RE: DISC/24/0174 Greenway Academy Greenway – Amanda Wilkes 29/07/2024

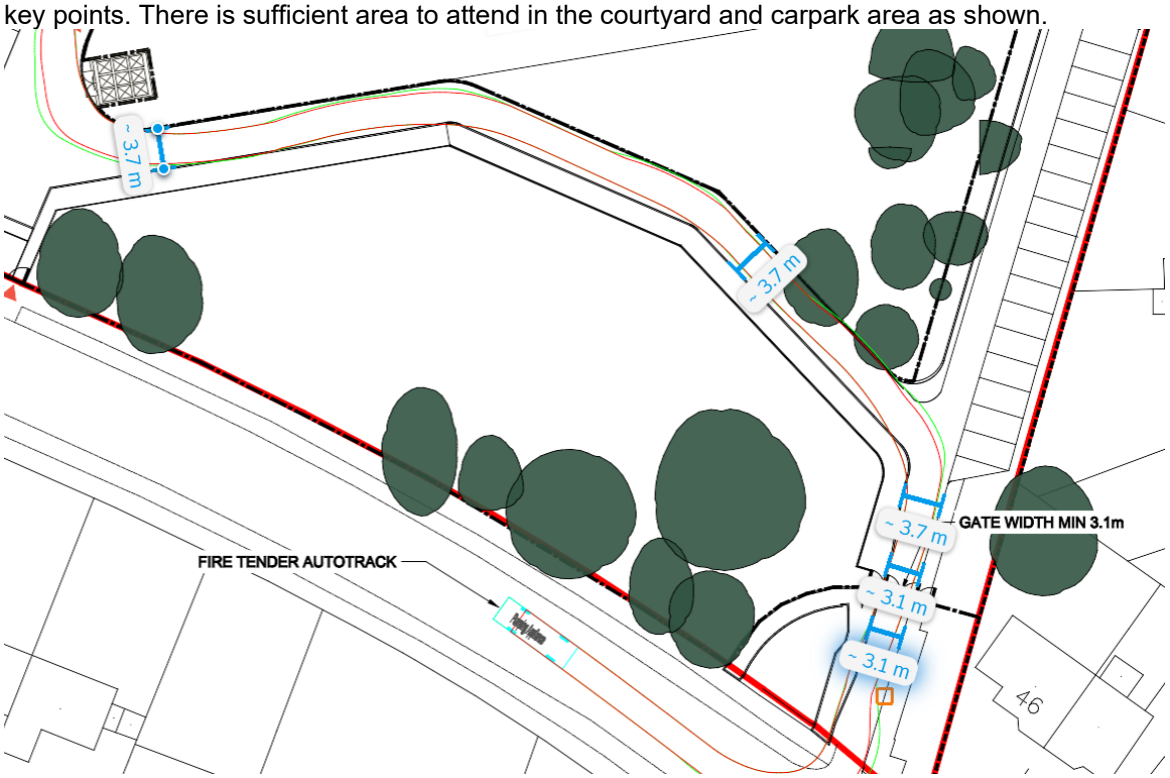
Please provide *'more information to establish if all the requirements of Approved Document B (AD-B) Volume 2: B5 section 15 and Building Bulletin 100: Fire Safety Design for Schools Section 23 & 24, (which requires pretty much the same), have been met My first report wrongly quoted section 8.3 of BB100 which was incorrect and misleading.*

The main access route shown on the fire appliance access strategy shows the entrance gateway has a clearance of 3.1m and a gateway into a hard informal & social courtyard clearance of 3.1m, but there is no information provided regarding the access route, we need clarification the road width meets with AD-B Volume 2 section 15 Table 15.2 & BB100 Table 19, to ensure a fire appliance can gain access. Both documents require 3.1m through any gateway or narrowing and 3.7m width of road or track between kerbs or road edge. Is there sufficient operating area adjacent to the school to operate the fire appliance when attending an incident, particularly as there are car parking spaces in this area.

If a fire appliance can gain access to the courtyard area, then the access requirement will be met, i.e., 15% of the perimeter of the building or 45m of every point of the footprint of the building, whichever is less onerous. Not clear if the courtyard and fire appliance are to scale and the fire appliance can gain access further into the courtyard area, and have the ability to turn and make their exit from the courtyard in a forward direction.

All areas a fire appliance is required to access, need to be capable of supporting 18 Tonne axial weight of a fire appliance, the fire appliance access strategy does not give any information what the access road is made of. AD-B and BB100 requires a minimum carrying capacity of any carriageway is designed to a minimum 12.5 Tonnes; a fire appliance weighs 18 Tonnes, but the weight is distributed over several axles, so 12.5 Tonne should support the weight of the fire appliance..'
